PLANNING, ZONING, & BUILDING DEPARTMENT
PZ&B Staff Combination Memorandum: Architectural Commission and Town Council

SUBJECT: ARC-24-0114 (ZON-24-0092) 1010 N LAKE WAY (COMBO)

MEETING: JANUARY 29, 2025, ARCOM
FEBRUARY 12, 2025, TC

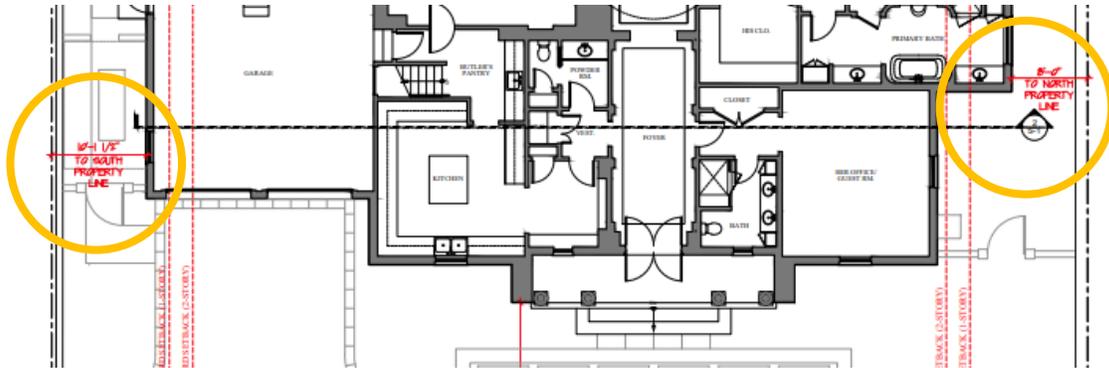
The first variance relates to an expansion of the lot coverage due to the proposed new loggias. It is a fairly small increase because of open air spaces.

Code Section	Permitted	Proposed	Variance
<u>Variance 1:</u> Sec. 134-893(11)b.	30% lot coverage	34.1% lot coverage (31.2% existing)	4.1%

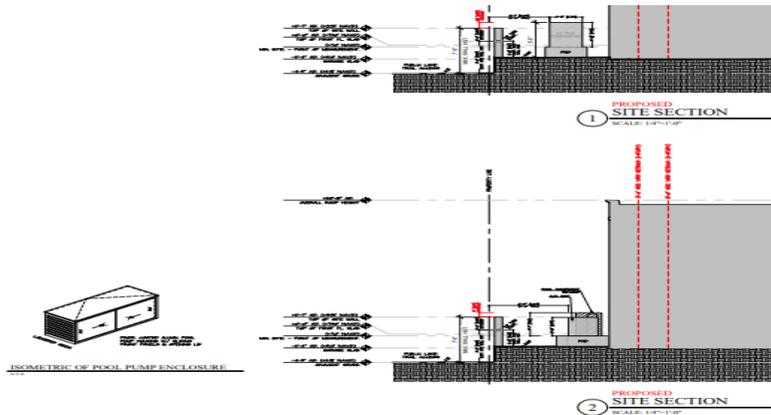
The fourth variance relates to the screening of the proposed generator and pool equipment. Landscaping and a shorter a wall is proposed as the screening.

Code Section	Required	Proposed	Variance
Variance 3: Sec. 134-1729(1) (d).	Wall to screen mechanical equipment	landscaping	full
